RE: SEP TOPIC IX-3, GINNA

Enclosed is a copy of our draft evaluation of Systematic Evaluation Program Topic IX-3, Station Service and Cooling Water Systems.

DRAFT SEP REVIEW  
OF  
STATION SERVICE AND COOLING  
WATER SYSTEMS  
TOPIC IX-3  
FOR THE  
R. E. GINNA NUCLEAR POWER PLANT

FIGURE 1

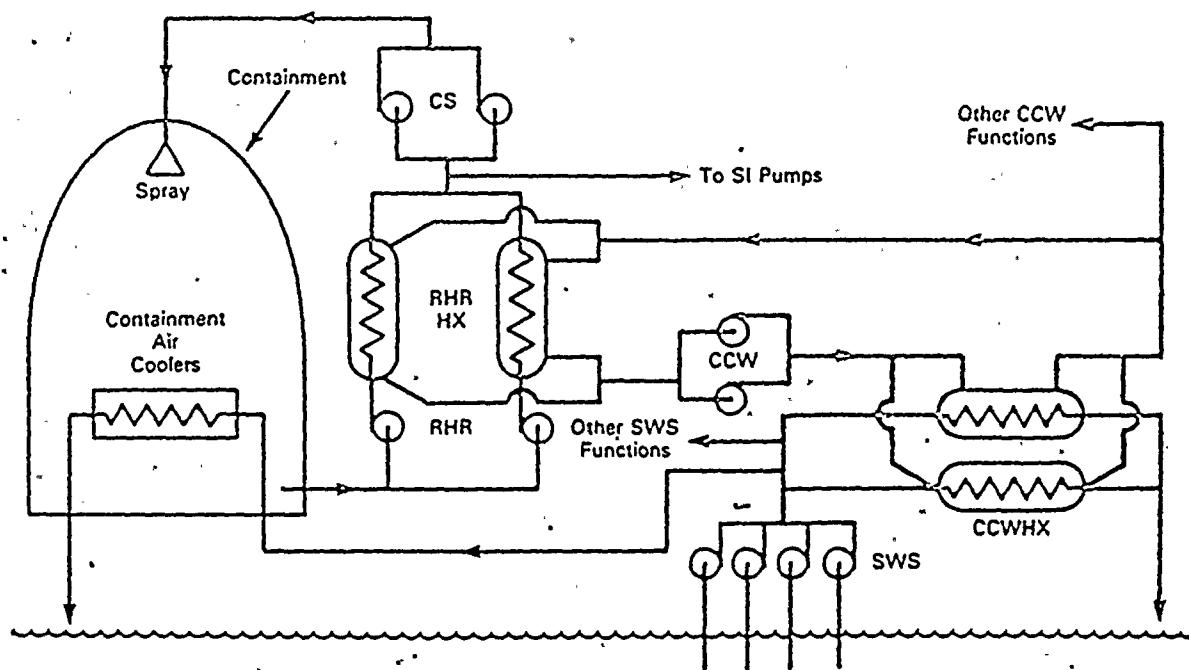
During the initial period of energy release to the containment, the heat is absorbed in various passive heat sinks inside containment. When the containment heat removal systems are initiated, the SWS is the first cooling water system to assume a heat load since the fan coolers start to remove heat directly from the containment atmosphere. At the design heat removal rate of the fan coolers (Table 1), the SWS temperature at the cooler exit is 174°F which is well below the design temperature limit of 200°F. The heat removed from the containment by the CS system is collected in the containment sump until the recirculation phase of the accident commences (after from 31 to 54 minutes). During recirculation, the sump fluid is recycled via the RHR system (and the RHR heat exchangers) back to the CS pumps for reuse. The sump water temperature would be approximately 250°F at the start of recirculation (Reference 3, Appendix 6E, Figure 1). Using Figure 14.3.4-9 of Reference 3 to determine the rate of energy addition to the containment at start of recirculation (119 E6 BTU/hr), the staff performed a heat balance on the CS, CCW

and SWS (Figure 1). The results of this calculation show that the CCW and SWS have sufficient capability to remove the post-LOCA heat loads with approximately 47 E6 BTU/HR accommodated by CS and approximately 72 E6 BTU/hr by the fan coolers at the start of recirculation. The normal system lineup is shown in Figure 1 for initial recirculation operation with a failed diesel generator. The heat loads are accommodated without exceeding RHR or CCW design temperatures which are 400°F and 200°F, respectively, and without operator action to adjust SWS or CCW system flows.
